Subject: East Altamont Energy Center Application for Certification
Data Request Response Set #1 (01-AFC-04)

East Altamont Energy Center
Data Requests and Responses (01-AFC-4)
Set #1

EAST ALTAMONT ENERGY CENTER DATA REQUEST AND RESPONSE SET #1 (01-AFC-4)

Technical Area: Visual Resources

Figure Vis 3-14
View from KOP 5. The Tracy Substation is the illuminated facility visible in the middleground.

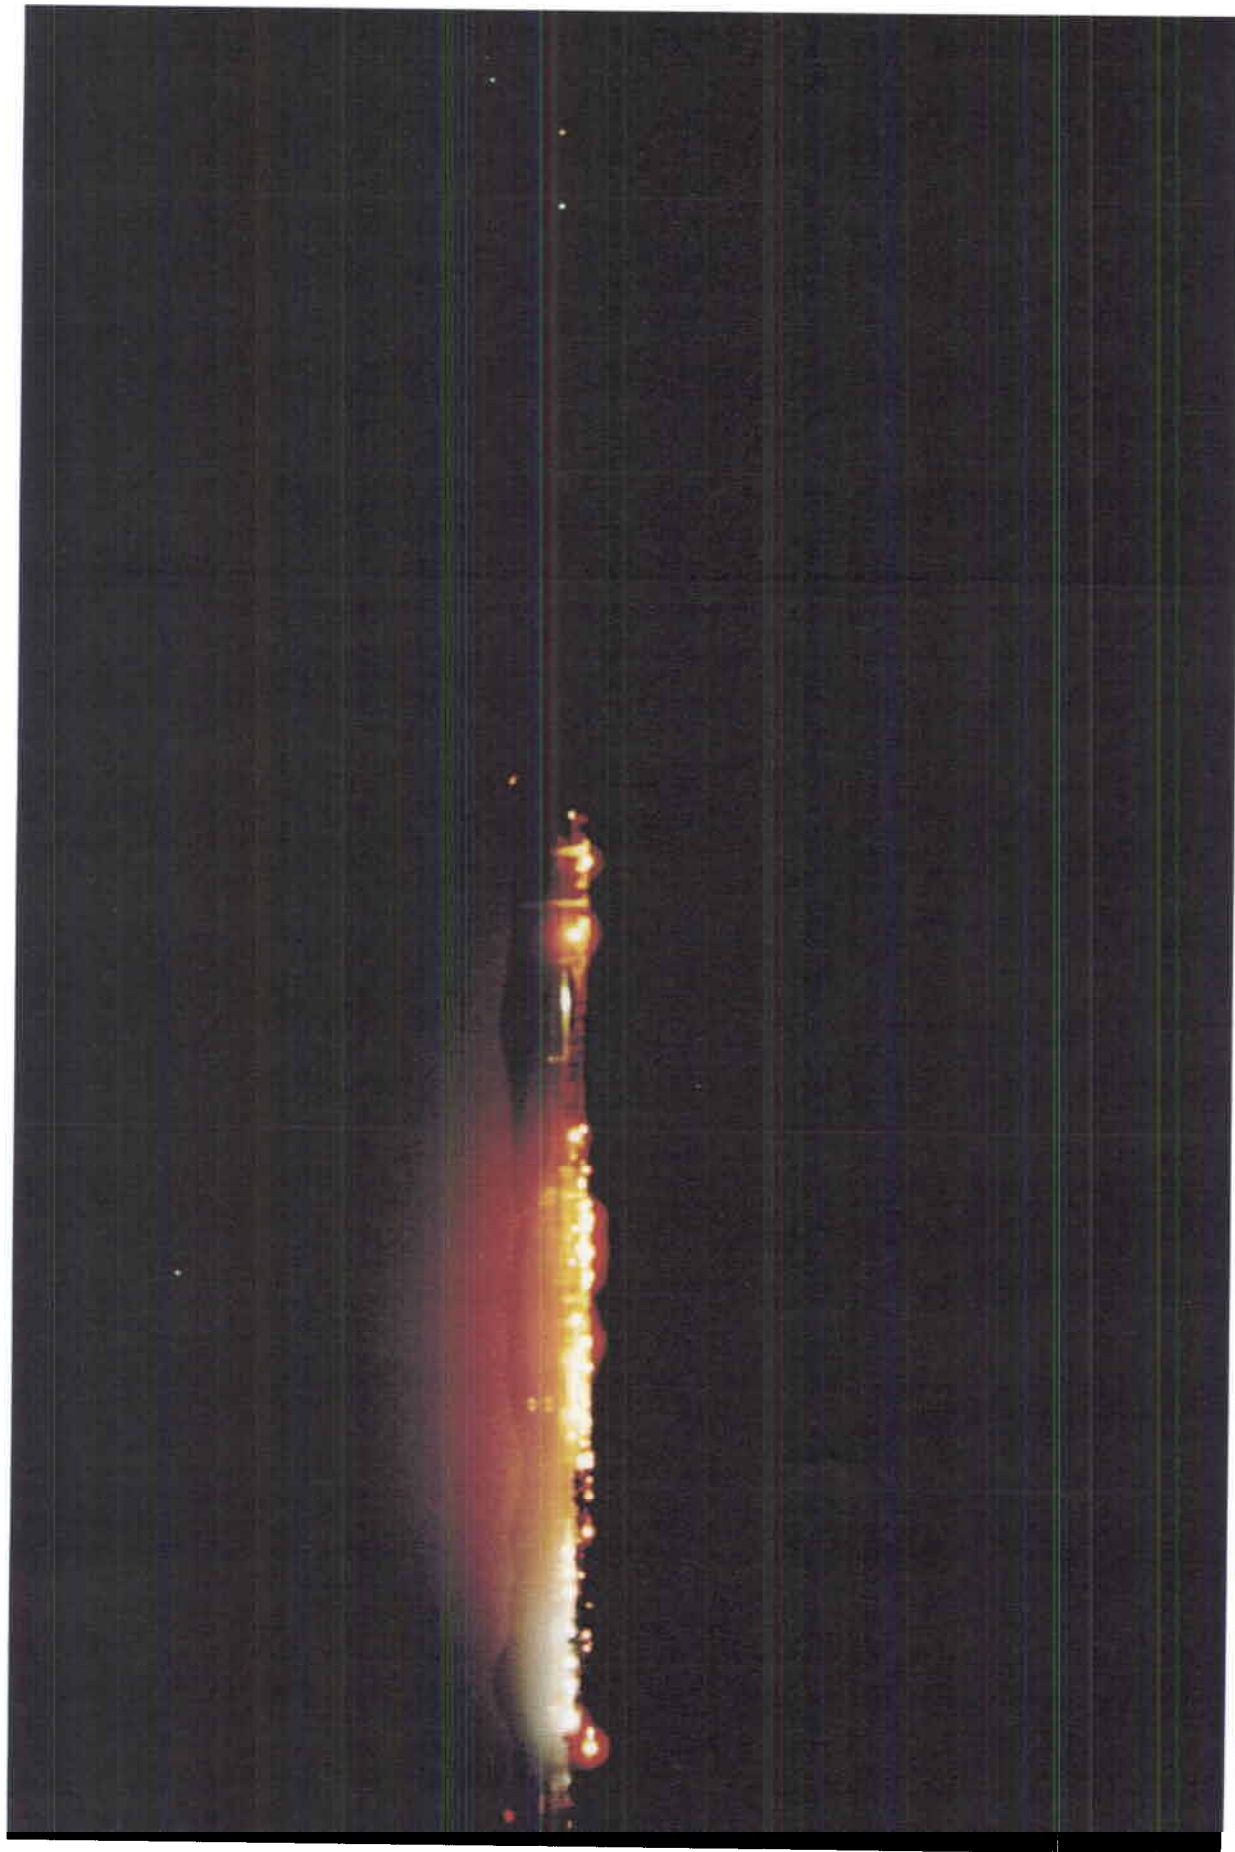
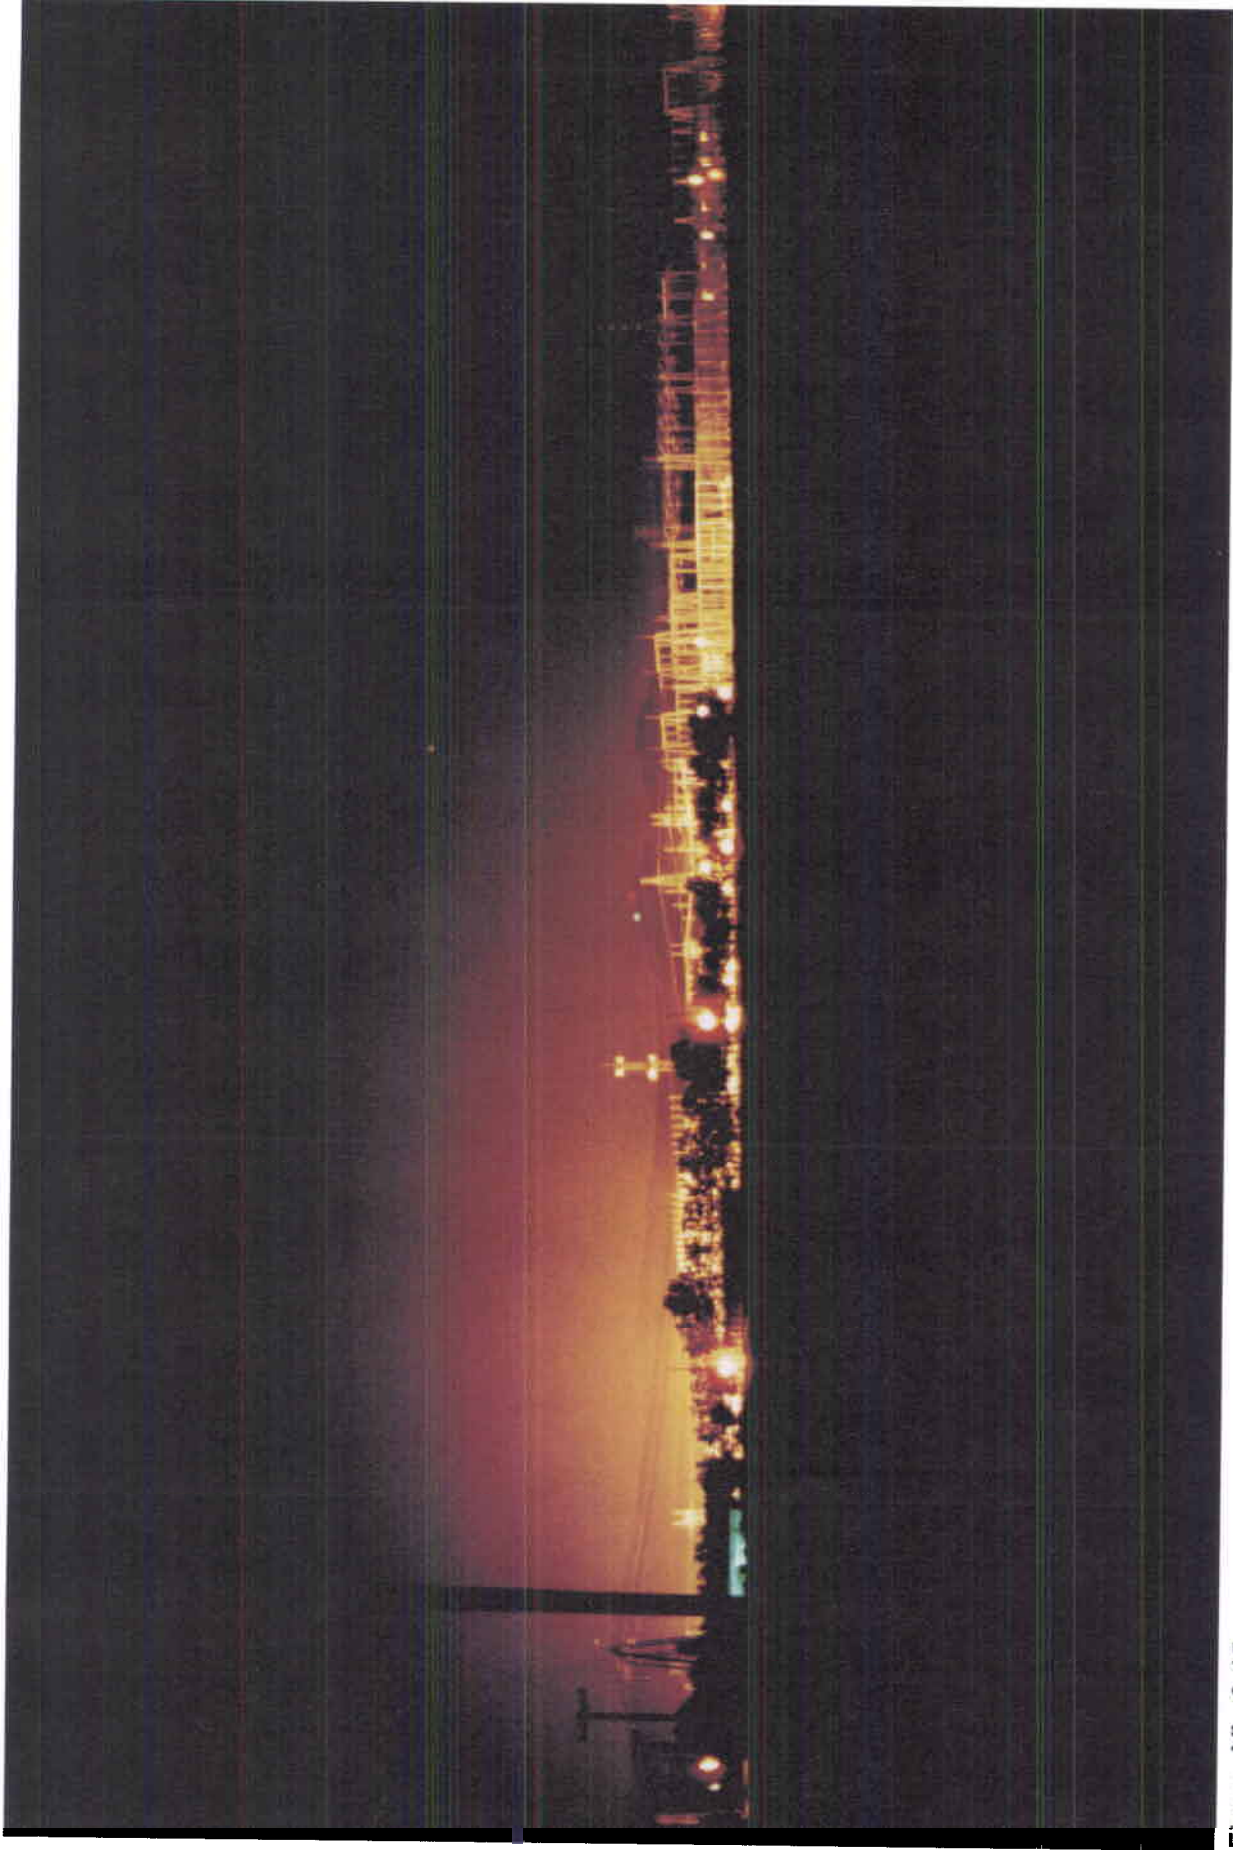
- 3. Please provide five sets of high-resolution color photocopies, at life-size scale when viewed from a distance of 18 inches, of a photograph of the existing view toward the proposed power plant site from KOP 5 at night.

Response: Attached is a sets of high-resolution color photocopies, at 11 x 17, of a photograph of the existing view toward the proposed power plant site from KOP 5 at night.

As a further response to this data request, we are also submitting the following documentation of the night lighting conditions that now exist in the vicinity of the project site.

The Western Area Power Administration's Tracy Substation is located across Mountain House Road, immediately to the southeast of the EEAC site. The equipment in this large facility is brightly lit at nighttime. Figure Vis 3-2 is a night view of the 500 kV switchyard as seen from the east. Because there is no landscaping or solid fencing around this portion of the substation, the brightly illuminated equipment is fully visible, and light from the substation extends into the surrounding landscape. Figure Vis 3-3 is a view of the 230 kV substation, seen from Kelso Road. Although the tree hedge along Kelso Road reduces the visibility of the highly illuminated equipment from the surrounding area to some extent, there are places like the one visible in the photo where there is no landscaping, and the brightly lit equipment is readily visible.

Figure Vis 3-4 is a view of the Central Valley Project's Tracy O&M Complex, which is located adjacent to Tracy Pumping Plant. This complex is located approximately 0.6 miles southeast of the EAEC project site. The complex's parking lot lights and illuminated building facades are visible from Kelso Road and from the cluster of rural residences that lie across the street from it.

Figure Vis 3-5 is a view from Kelso Road looking west toward the PG&E gas compressor station. This compressor station lies approximately 1.3 miles to the southeast of the project site. As this photo indicates, the structures and yard are brightly lit, and cast ambient light into the surrounding area.

Figure Vis 3-6 is a view of the Department of Water Resources' Banks Pumping Plant, which is located at the base of the hills 2.4 miles to the west of the project site. As this photo suggests, the substation and buildings at the pumping plant complex are brightly lit, and cast a glow into the sky.

Figure Vis 3-7 is a view of the Department of Water Resources' Skinner fish screening facility located at the California Aqueduct's intake at Clifton Court Forebay. This facility is located 1.3 miles north of the project site and is highly visible from the nearby Byron Highway. As the photo indicates, the structures and outdoor areas at the Skinner Facility are brightly lit, and the lighting casts a glow that extends into the surrounding area.

Night lighting in the project area is not restricted to the major infrastructure facilities. Frequent use of outdoor security lights is made at individual farm and residential properties as well. In addition, Mountain House School, which is located on Mountain House Road approximately 0.8 mile south of the project site is brightly lit at night by a porch light and a pole-mounted security light (Figure Vis 3-8).

set of extremely bright temporary floodlights has been installed (Figure Vis 3-9). These floodlights cast a pronounced glow into the sky, and can be seen for miles around.

Figure Vis 3-10 is the nighttime view from KOP 1. The brightly illuminated 500 kV switchyard at the Tracy Substation, which is located across Mountain House Road and to the immediate southeast of the project site is visible in the right half of the photo. Figure Vis 3-11 is the view from KOP 2. The Tracy Substation's 500 kV yard is visible at the left edge of the view, on the west side of Mountain House Road. As the photo indicates, the substation casts a glow that illuminates the transmission lines along the eastern edge of the road, and even illuminates a portion of the surface of the project site.

Figure Vis 3-12 is the view from KOP 3, the viewpoint located on Mountain House Road directly in front of Mountain House School. In this photo, stray light from the security lighting at the school (see Figure Vis 3-8) illuminates the roadway in the immediate foreground of the view. Light from the Tracy Substation is visible in the distance in the middle of Mountain House Road. The glow from the substation is so bright that it illuminates the steel pole transmission tower located on Kelso Road just to the east of Mountain House Road.

Figure Vis 3-13 is the view from KOP 4, the viewpoint located in front of a residence on Kelso Road at a point half way between Mountain House and Byron-Bethany Roads. In this view, the brightly illuminated equipment at the Tracy Substation is readily visible, as is the glow that the substation casts into the sky. The cluster of bright lights in the distance at the right side of the view may be from DWR's Skinner Facility.

Figure Vis 3-14 is the view from KOP 5, the viewpoint located at Lindeman Road's intersection with Byron Bethany Road. The brightly lit equipment at the Tracy Substation is highly visible in the center of the view. The bright construction floodlighting at Bethany Reservoir is visible in the distance on the view's left edge. The lighting from the substation and reservoir construction site combine to create a large area of glowing sky.

Figure Vis 3-15 is the view from KOP 6, the viewpoint established on Kelso Road 0.45 mile east of Mountain House Road to document the changes associated with the project's transmission line. At night, this view is dominated by the brightly lit equipment at the Tracy Substation, and by the glow it casts into the sky above.
